Docket Item # 8 BAR CASE # 2008-0092

BAR Meeting July 9, 2008

ISSUE: Alterations

LOCATION: 124 Quay Street

Figure 2. Existing deteriorating slate roof.

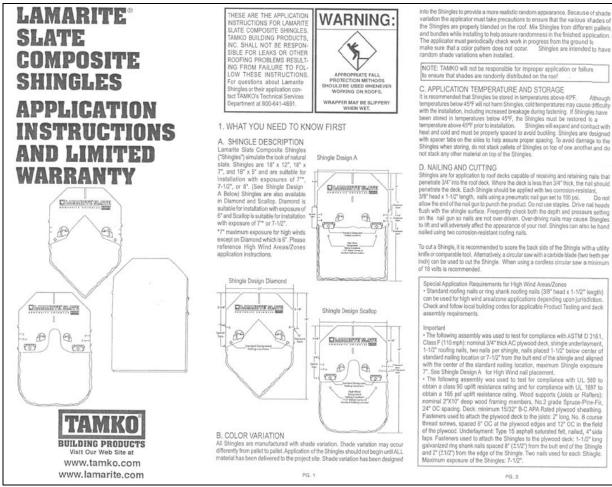
The applicant is requesting approval of a Certificate of Appropriateness to replace an existing deteriorating slate roof with a synthetic slate roof. The proposed synthetic slate is a colorized, mineral-filled polymer with the trade name LAMARITE. The applicant proposes to replicate the existing slate shingles in size and pattern.

124 Quay Street is a non-historic dwelling with historically compatible materials. While non-historic buildings and new construction are permitted greater flexibility in the selection and range of materials, in many circumstances the use of historically accurate materials contributes to the compatibility of new construction in the historic district. The development in which 124 Quay Street is located was constructed using authentic historic materials of slate and standing seam metal. It is unfortunate that in this circumstance, slate shingles, which typically last for decades, have significantly deteriorated and must be replaced. However, Staff finds that a replacement roof material should retain a sense of material integrity and be compatible with the historic materials found throughout the Old and Historic District. Therefore, Staff recommends that a more appropriate material, such as a standing seam metal roof, be used in place of synthetic shingle.

1. That the proposed roof be a historically appropriate material, such as standing seam metal or slate.
